• SUBJECT: 19EA OIL LOSS

F.E.R. 77-5

To advise the field of recommended troubleshooting techniques and repair procedures concerning 19EA Oil Displacement (Loss) problems.

19EA OIL LOSS

Fig. 1

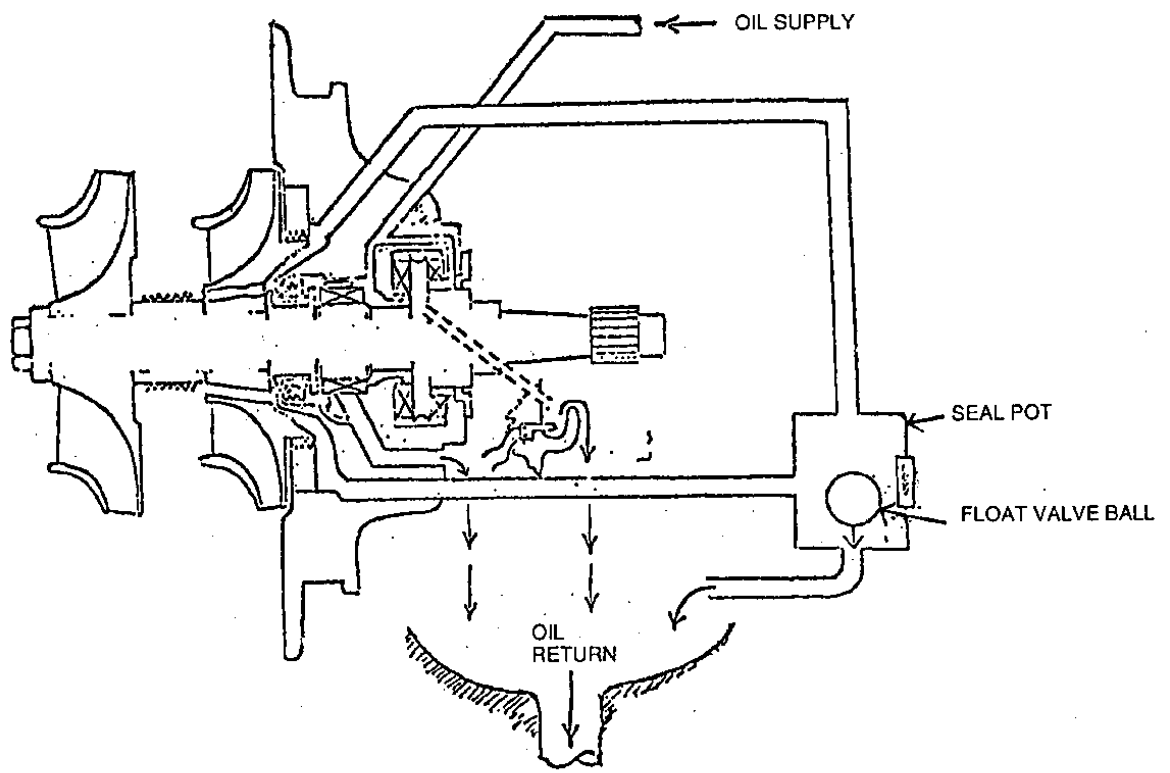
- 1.2.1 Raise oil temperature to 155^o F. If problem persists, proceed to STEP 1.2.2.
 - 1.2.2 Add an additional vent line between the transmission inspection cover and either the oil reservoir cover or thru the side of the shell into the oil reservoir. Use 3/4" to 1" pipe. SEE FIGURE 1.

Compressor Lubrication System
Fig. 2

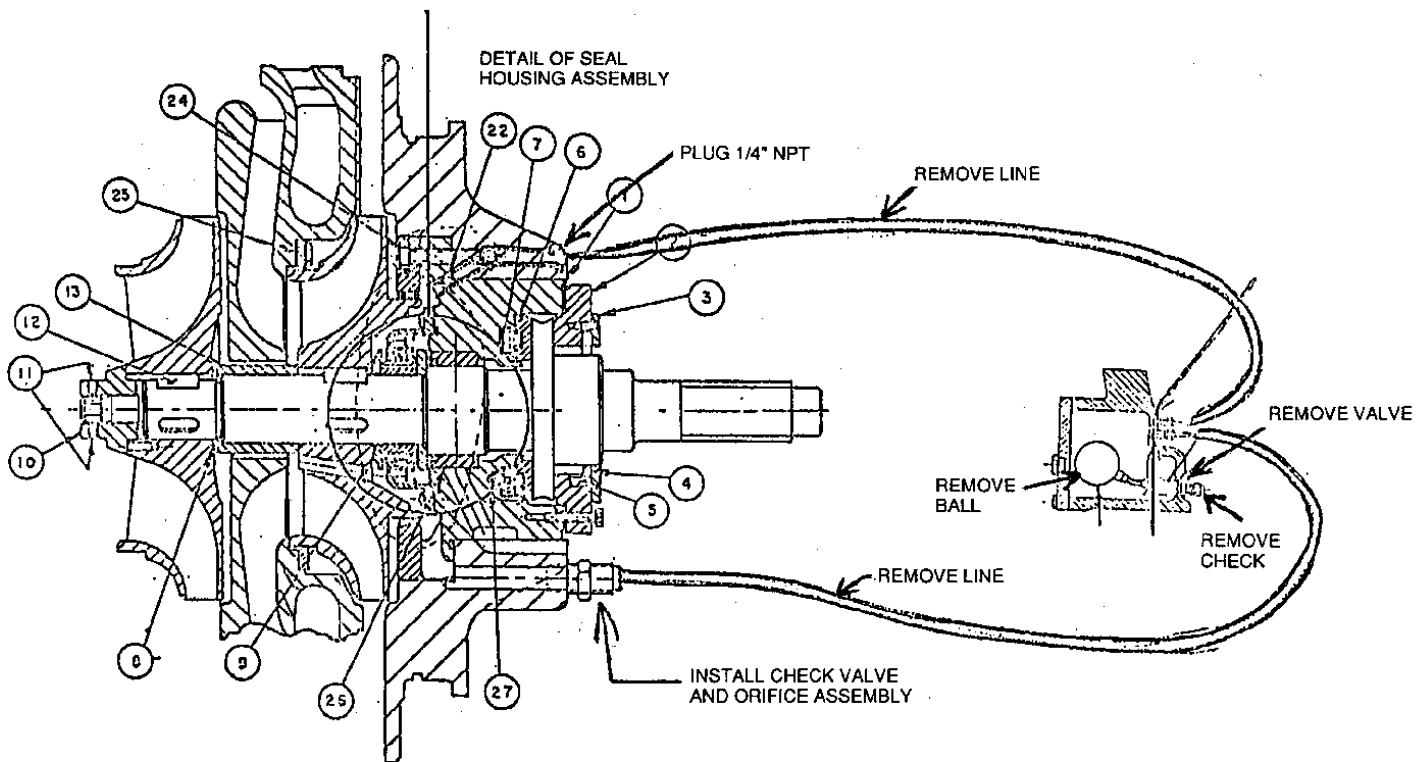
- 2.1 Early machines have a seal pot and float system (FIGURE 2). If the seal pot system is working, it is recommended that it be retained. The original design copper float ball has collapsed on occasion. This will be indicated by a full sightglass of oil. If a collapsed ball is found, and the assembly is to remain in use, replace it with a stainless steel ball, P/N EC28QZ-030.

ASSEMBLE CHECK VALVE
FILL BORE WITH SOLDER

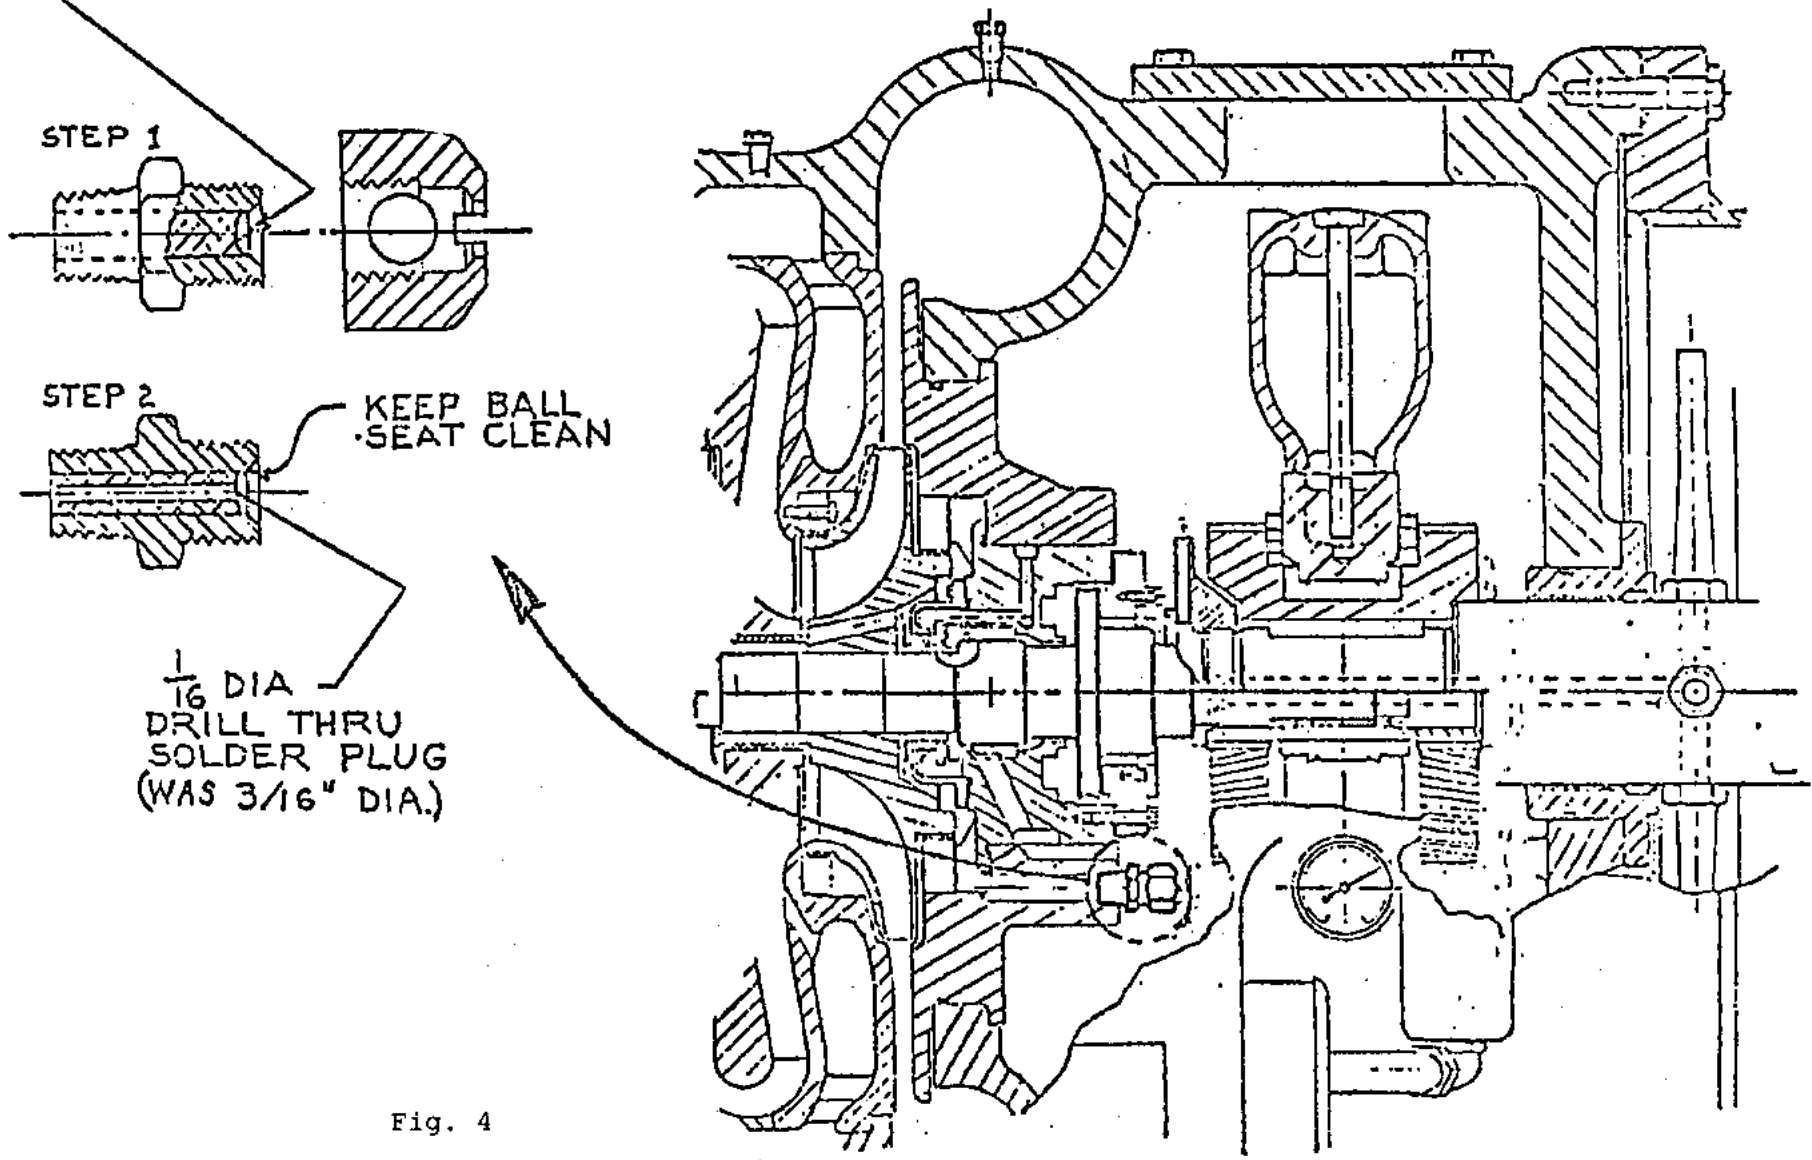
- 2.2 If a problem is suspected in the seal pot-float system, the check valve/orifice assembly should be installed in its place.
 - 2.2.1 Remove the float valve and check valve.

- 2.2.2 Remove the two lines between the float chamber and the discharge and bearing housing. SEE FIGURE 3. Plug the gas vent hole at the top of the discharge bearing housing.

- 2.2.3 Install the new check valve/orifice assembly, P/N19EA41-262, in the oil drain at the bottom of the discharge and bearing housing. The check valve/orifice assembly has a 3/8" male NPT connection which fits into a 3/8" hole in the discharge bearing housing.

1/16" Check Valve Orifices. (In Lieu of Seal Pot and System)

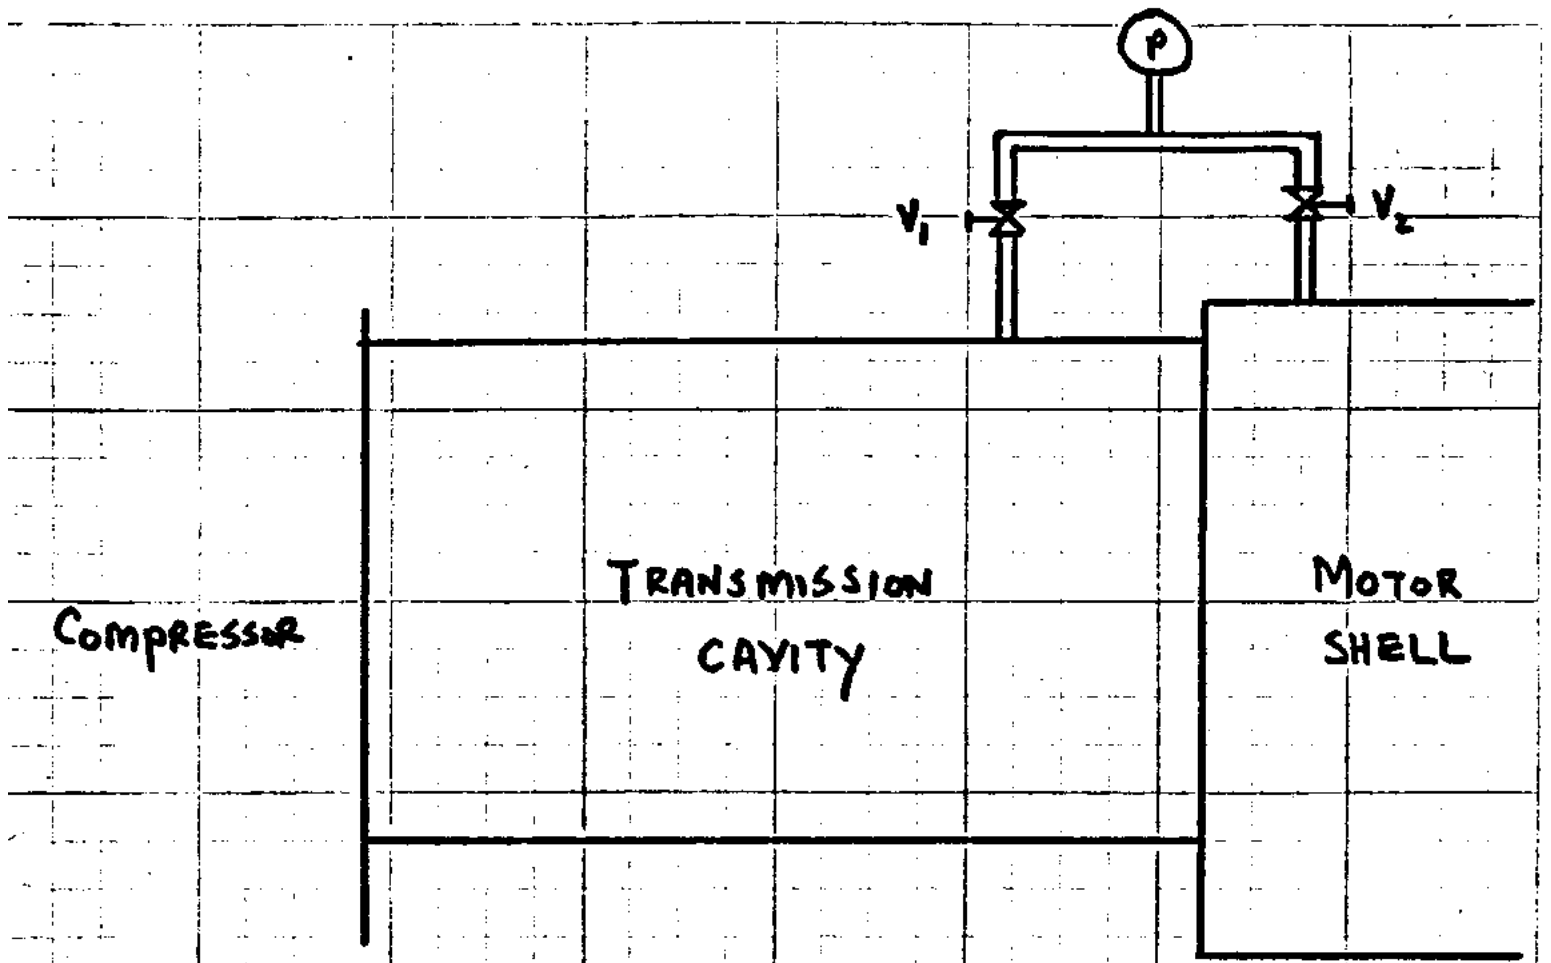
- 2.3 Later machines have a 3/16" orifice blowing refrigerant gas and seal leakage oil from behind the second stage wheel into the transmission cavity. Experience has shown that the centrifugal demistor can not handle the volume of gas from this size orifice (especially if any other leakage is present). These orifices should be modified to a 1/16" orifice. New machines have this modification.
- 2.3.1 Remove check valve. It is extremely difficult to do this modification thru the transmission inspection cover. The compressor cap may have to be lifted. SEE FIGURE 4.
- 2.3.2 Solder 3/16" orifice closed on threaded end.
- 2.3.3 Drill thru solder with 1/16" twist drill.
- 2.3.4 Replace check valve in compressor.
- 2.4 The following chart outlines the seal system that may be on a machine by compressor serial number.

Method to Check Pressure Differential
Fig. 5

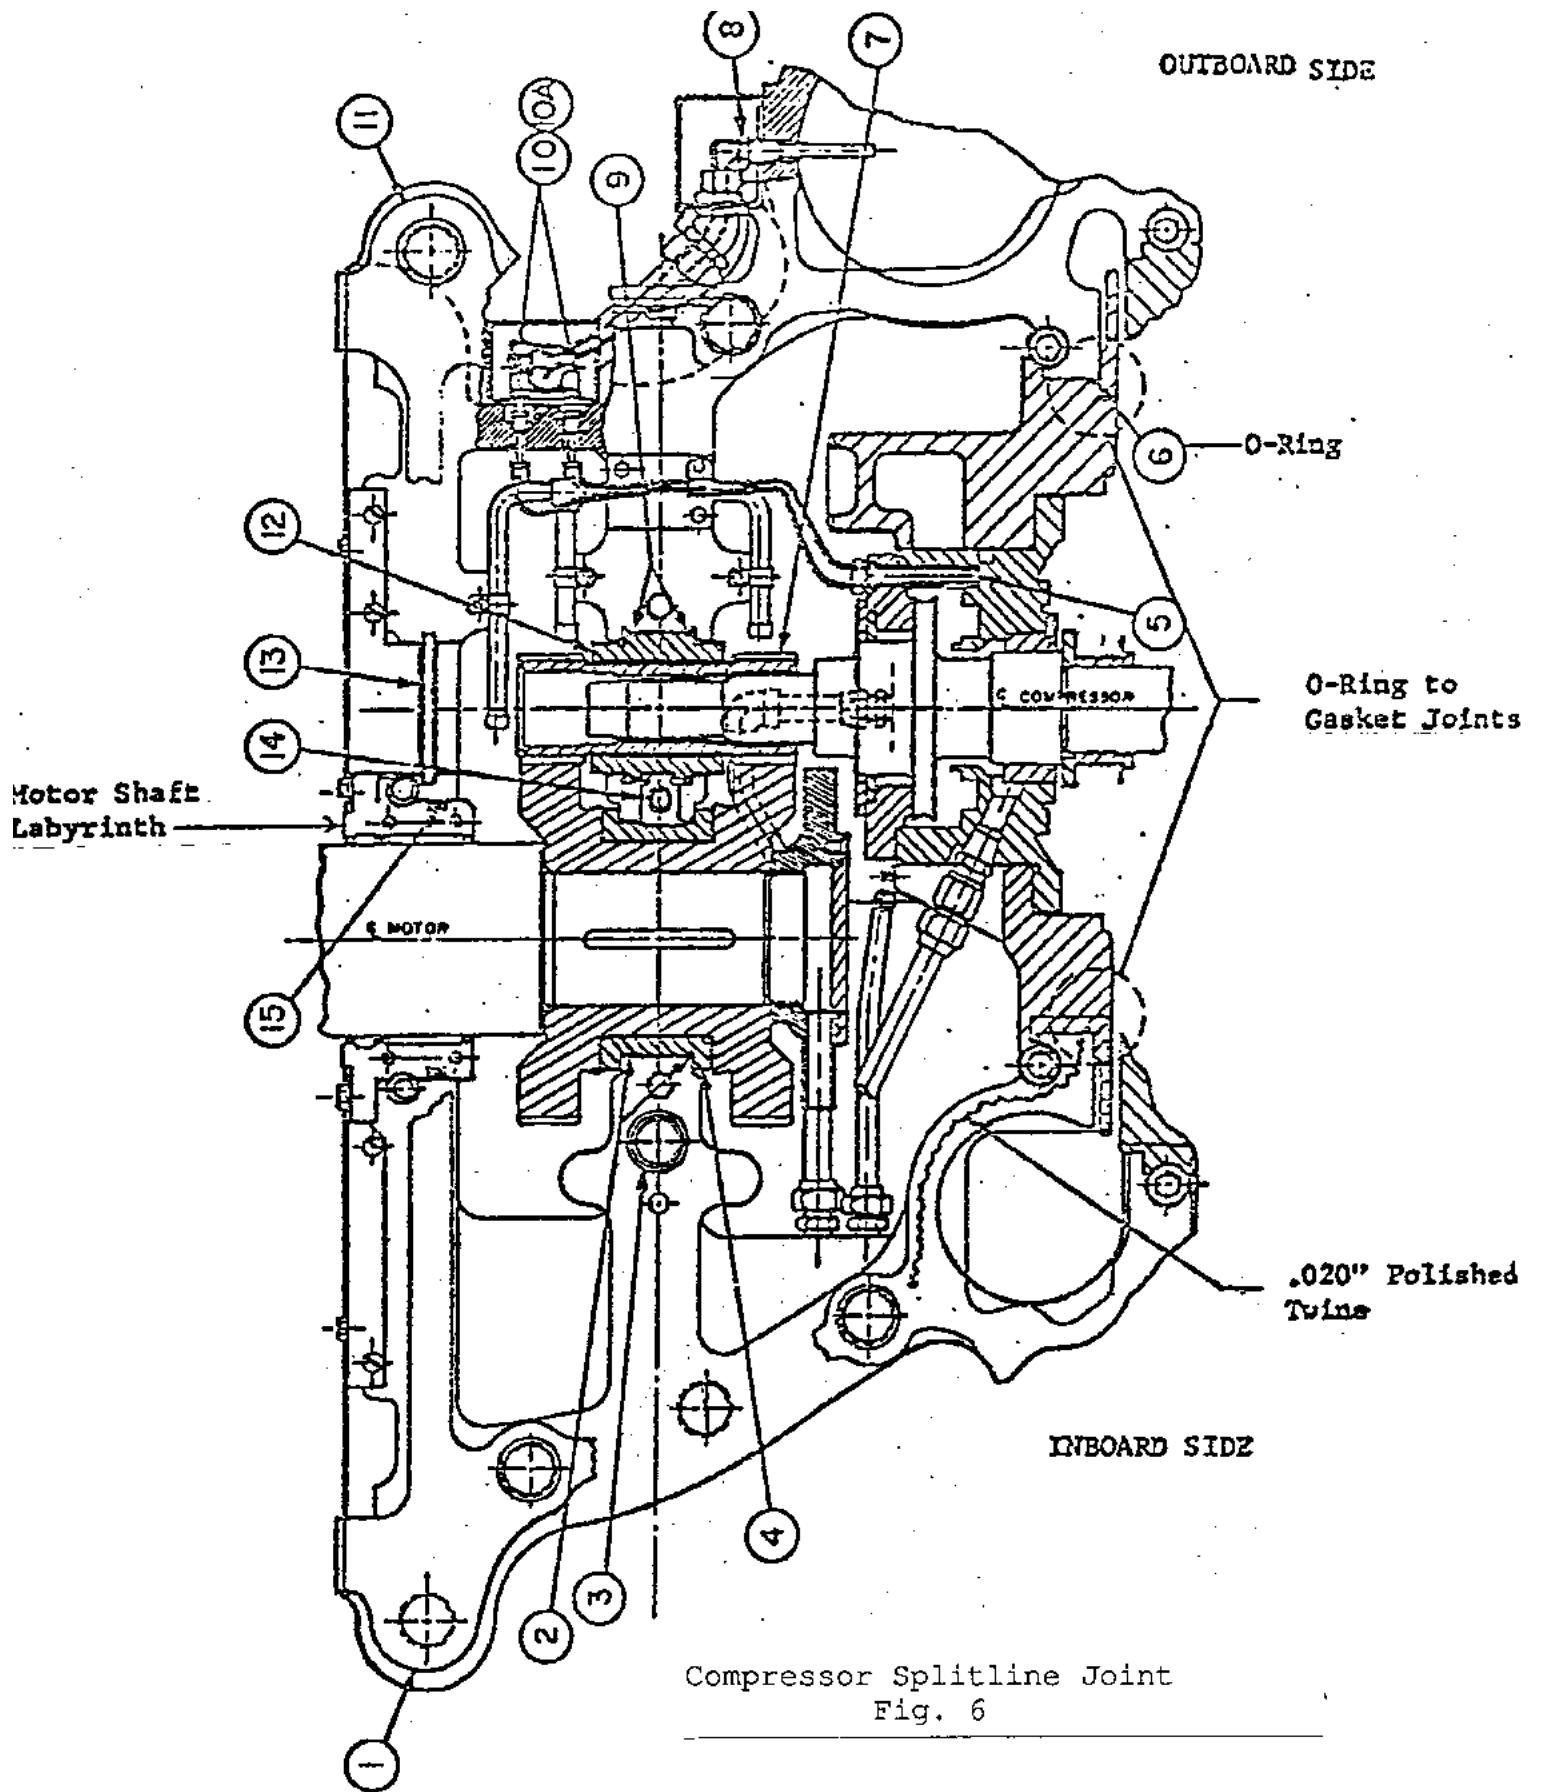
To test for this reversal of pressures, a pressure gage should be installed to measure the pressures in the transmission cavity and in the motor shell. SEE FIGURE 5 for a suggested hook-up. If the transmission cavity pressure is the greater of the two, a gas leak exists.

NOTE: EXTREME CARE MUST BE USED WHEN DRILLING INTO THE MOTOR SHELL. ANY METAL FILINGS WHICH ENTER THE MOTOR SHELL COULD CAUSE SERIOUS DAMAGE TO THE STATOR.

Rear Carbon Seal
Fig. 7

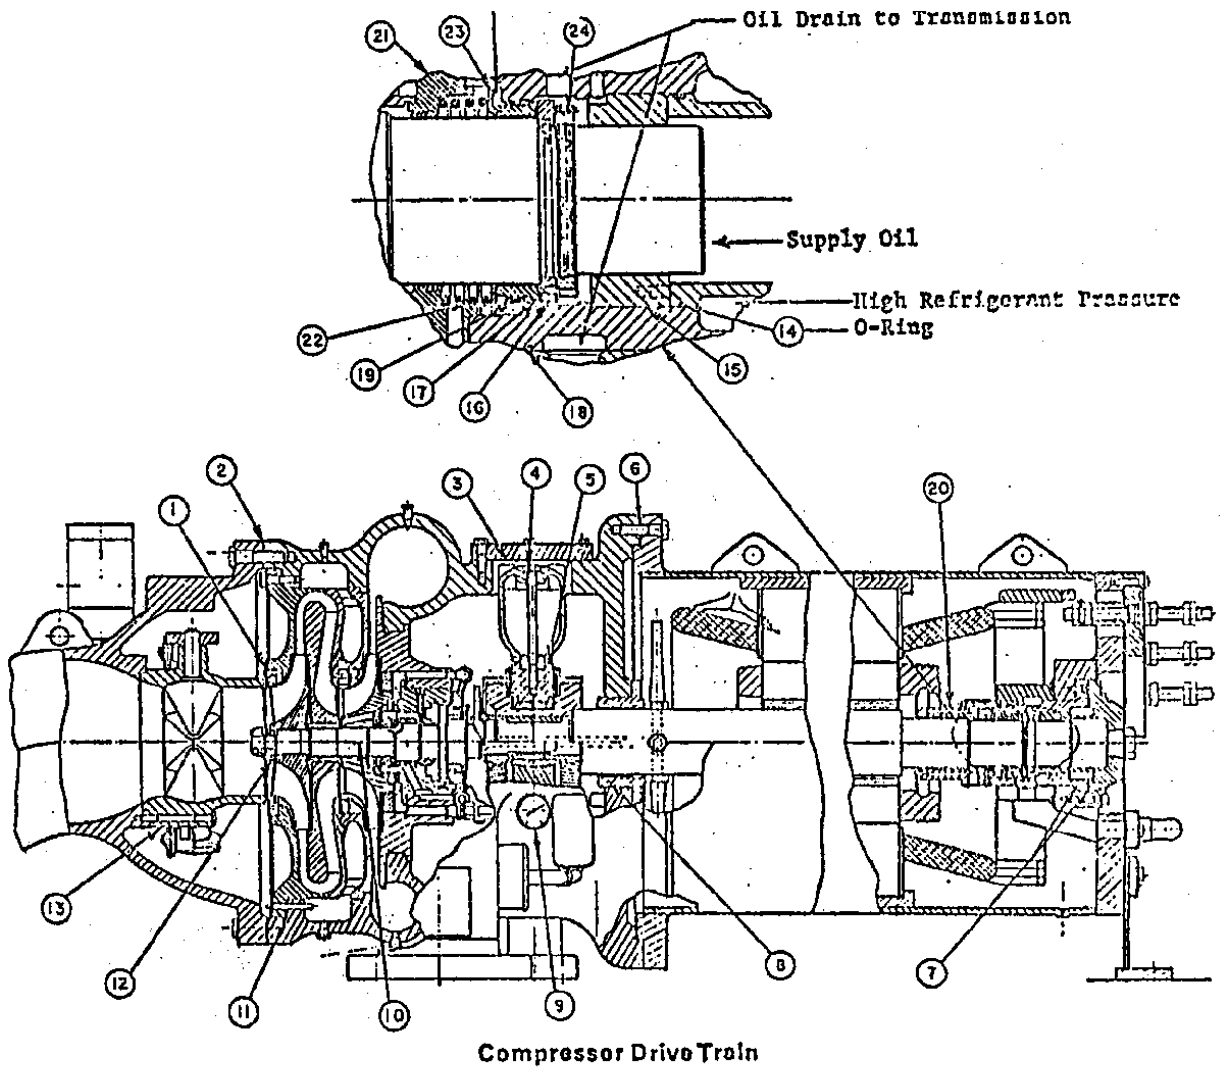
4.1 Leakage at the motor end carbon is not likely in a running condition since there is little pressure drop across the seal. At start-up, however, oil can be lost if the rear carbon is worn. Inspect and replace the seal if necessary. Check for binding of O-Ring (ITEM 19, FIGURE 7) against the seal ring by depressing seal ring against spring. Lubrication of O.D. of carbon ring will usually eliminate binding.

4.2 Motor cooling refrigerant may be mixing with the oil due to a bad O-Ring joint (ITEM 14, FIGURE 7). This will cause continuous oil foaming and low oil temperatures.
